**FINAL DRAINAGE REPORT
FOR
SADDLEHORN RANCH – FILING 5 EARLY GRADING**

**September 1, 2022
Project No. 25142.07**

El Paso County PCD File No.:
EGPXXX
EGP226

MAP NUMBER 08041C0558G
MAP REVISED DECEMBER 7, 2018
Federal Emergency Management Agency

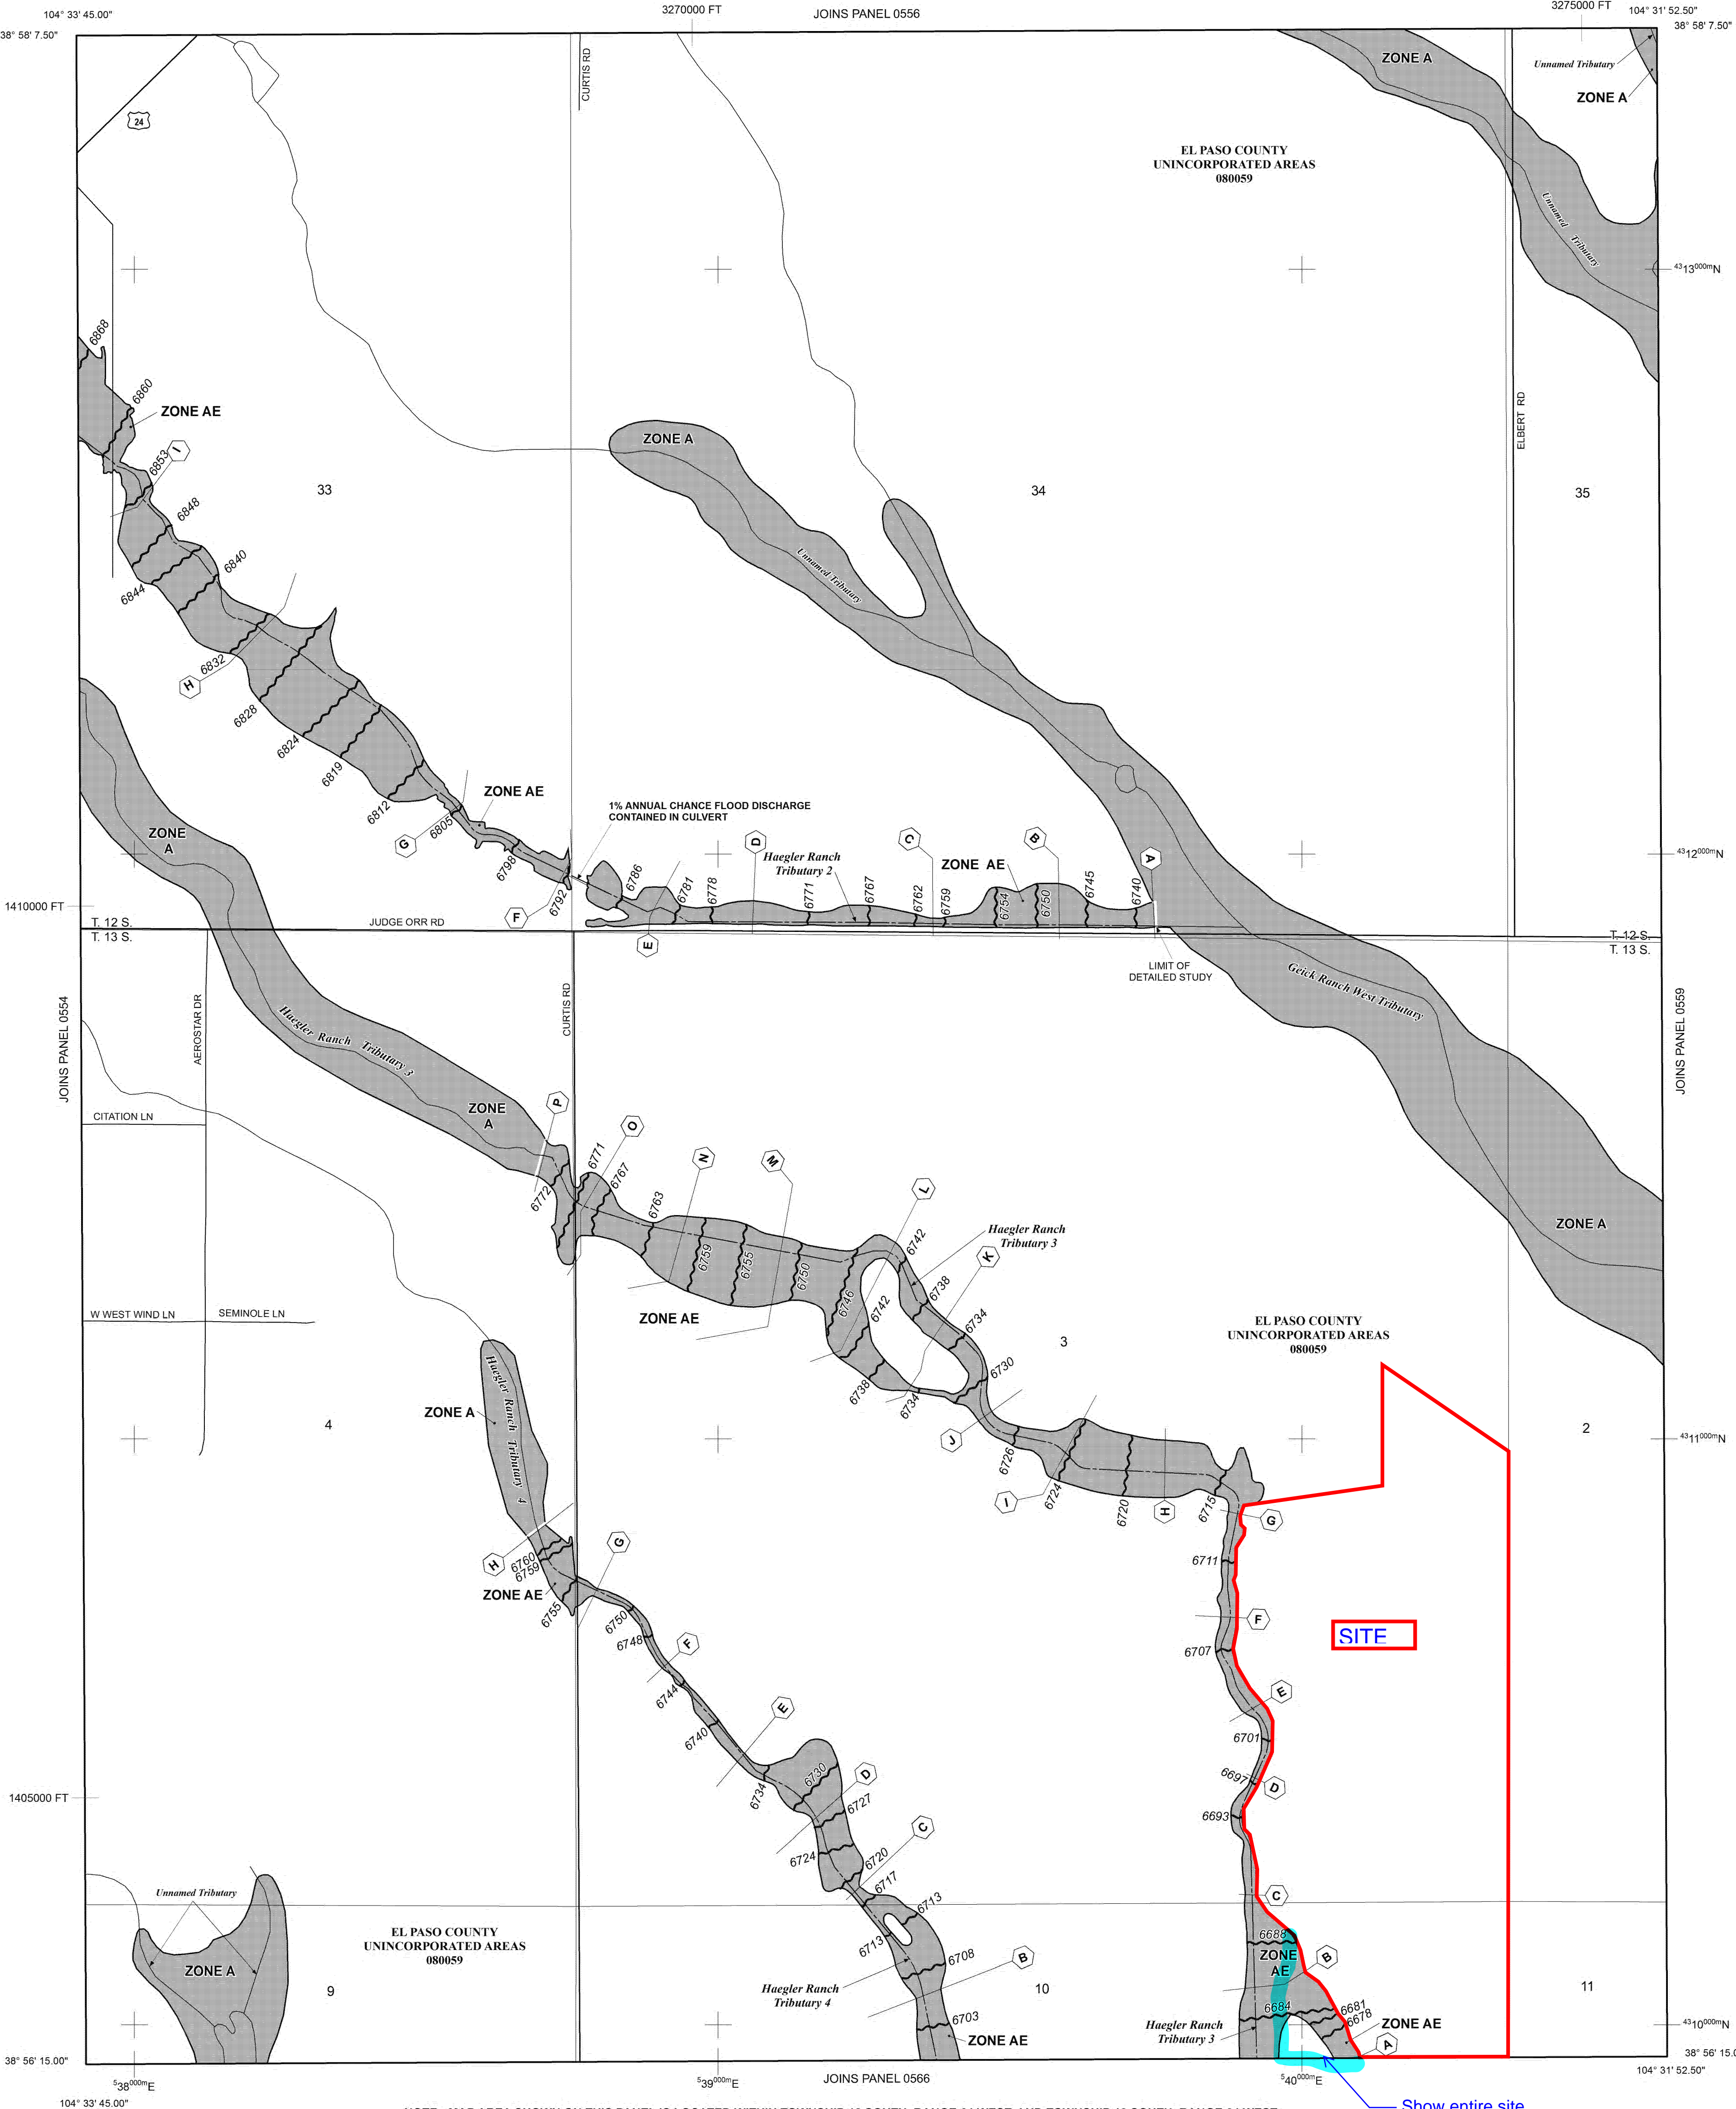
Show entire site

Culvert Report

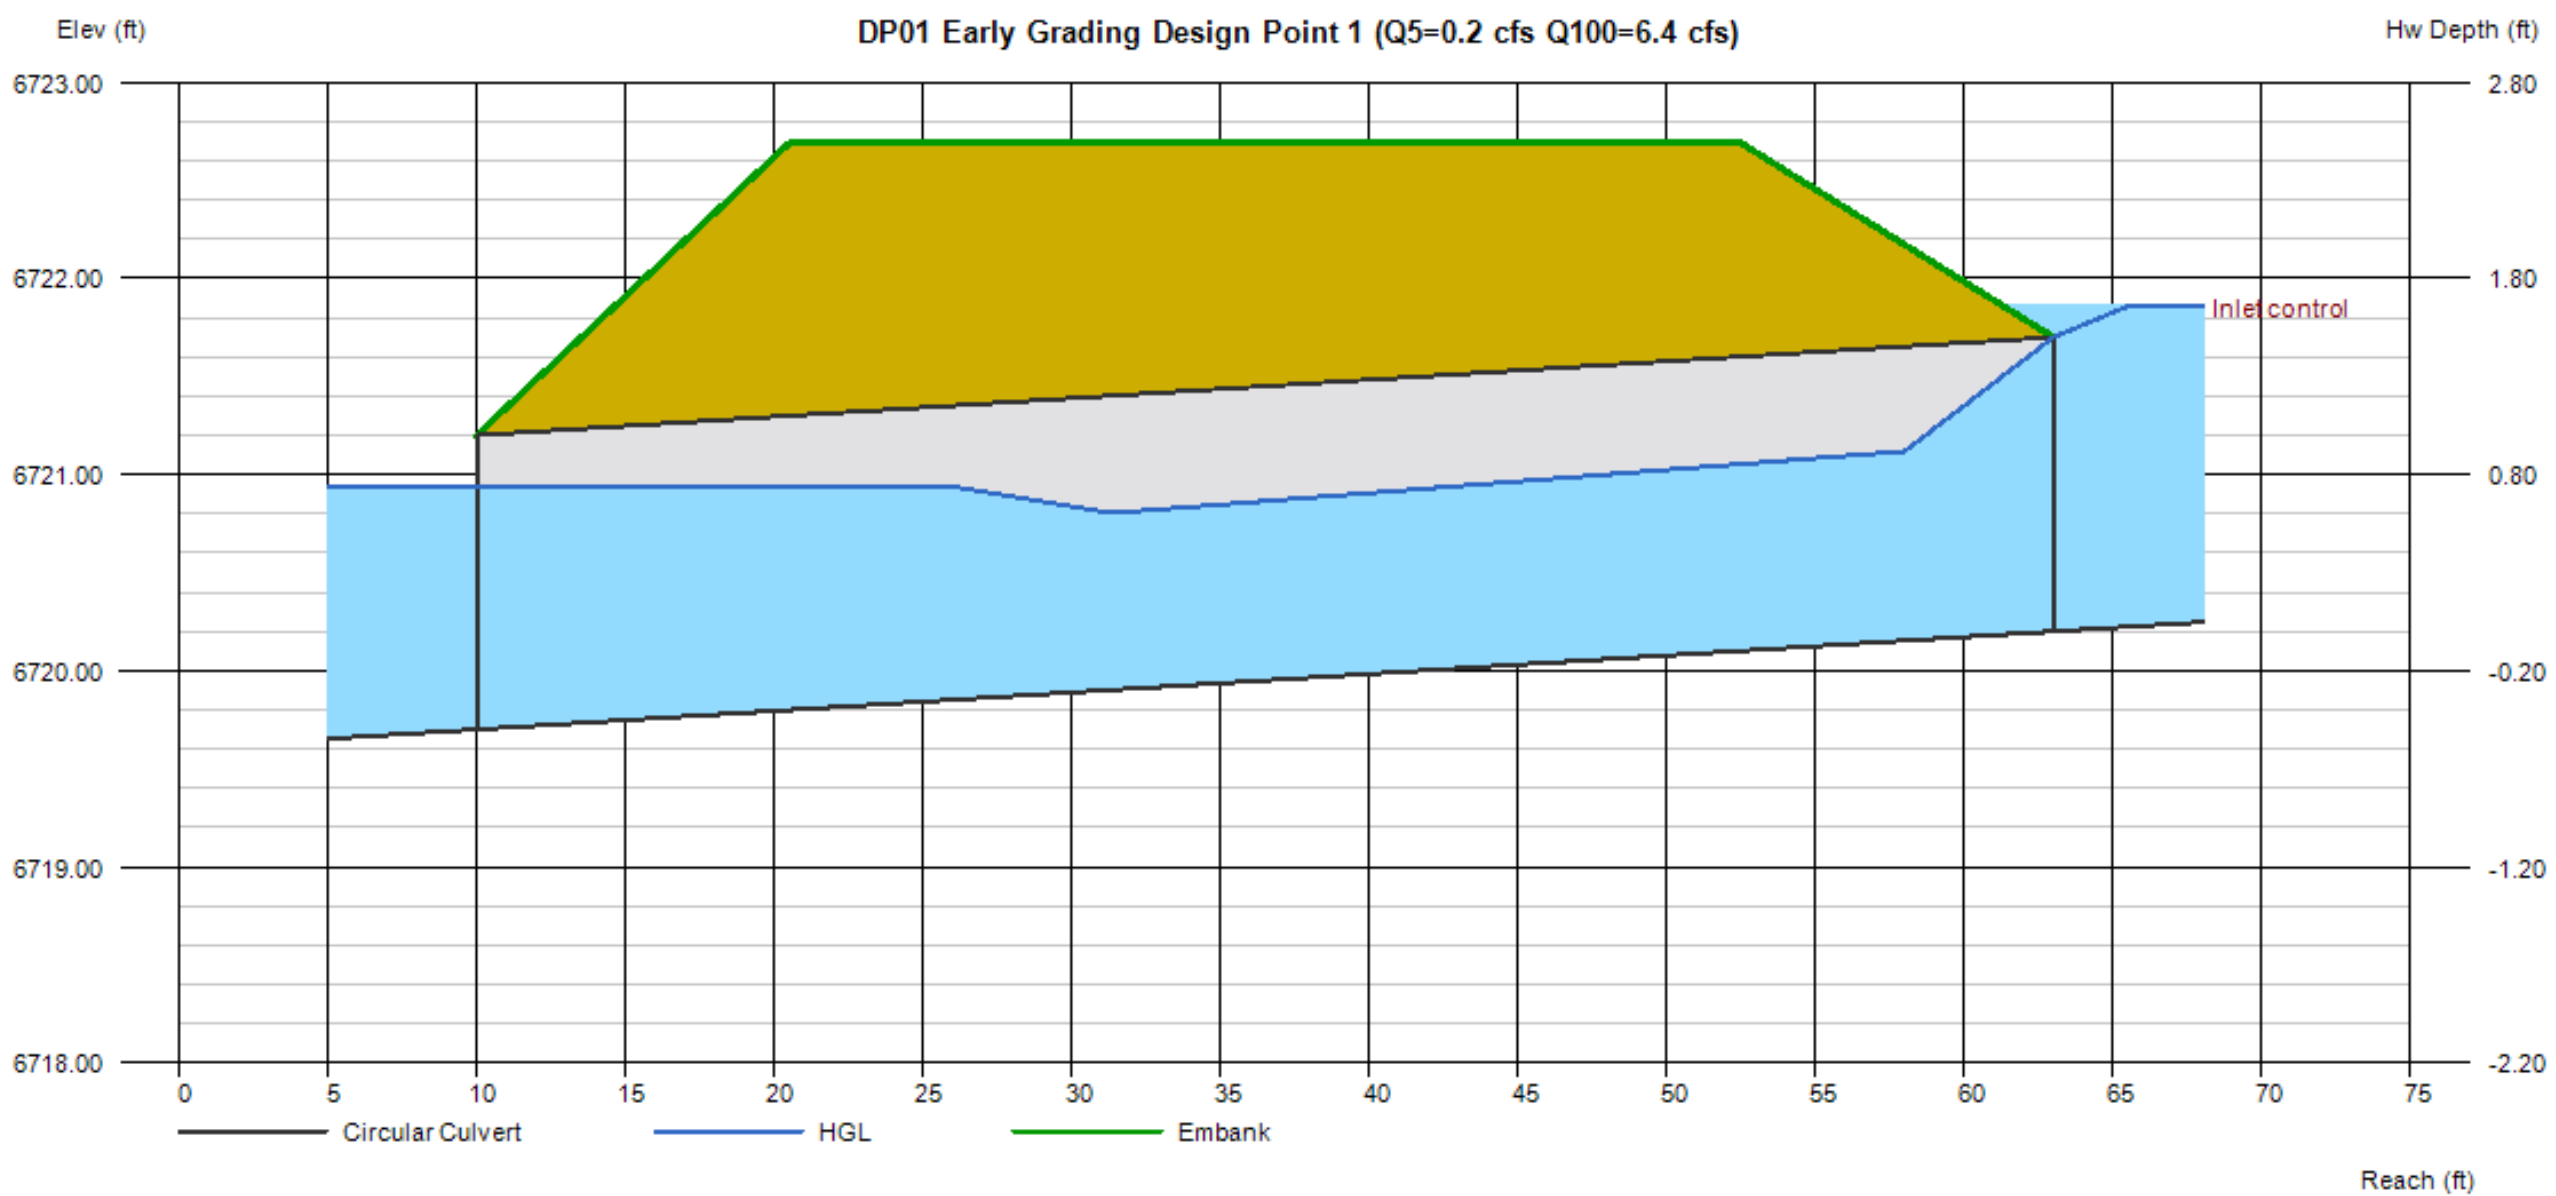
Flows do not match hydrology spreadsheet for DP 1.0. Please update sheet with flows shown on hydrology spreadsheet (0.3 & 11.4 cfs)

DP03 Early Grading Design Point 1.1 (Q5=0.3 cfs Q100=11.4 cfs)

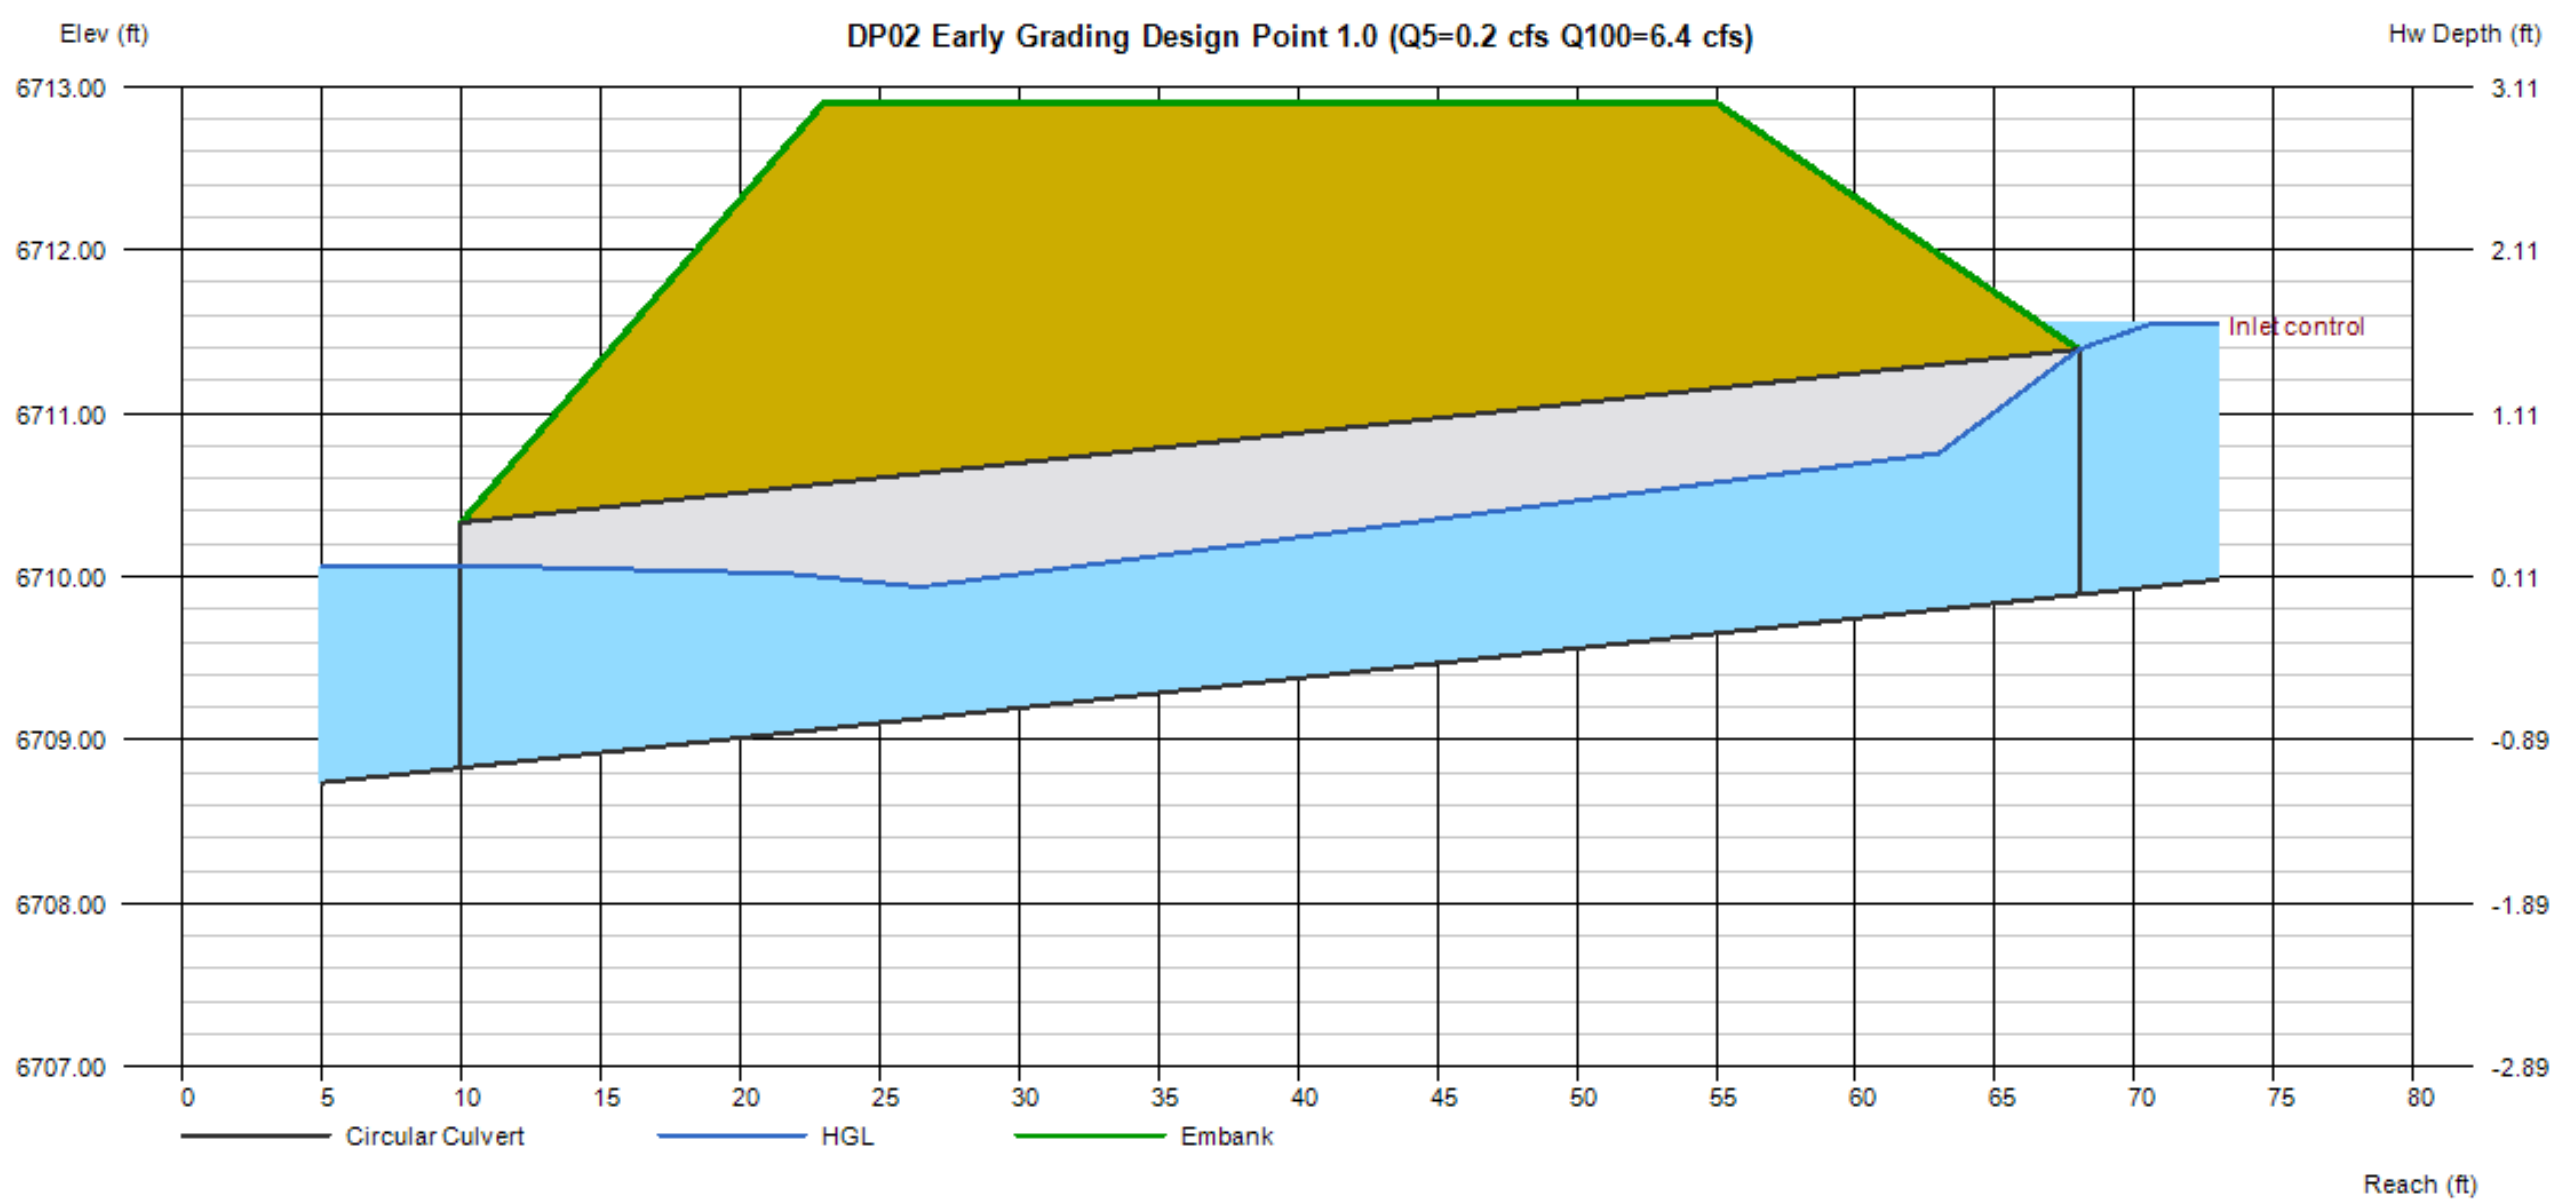
Flows do not match hydrology spreadsheet for DP 1.1. Please update sheet with flows shown on hydrology spreadsheet (0.4 & 15.2 cfs)
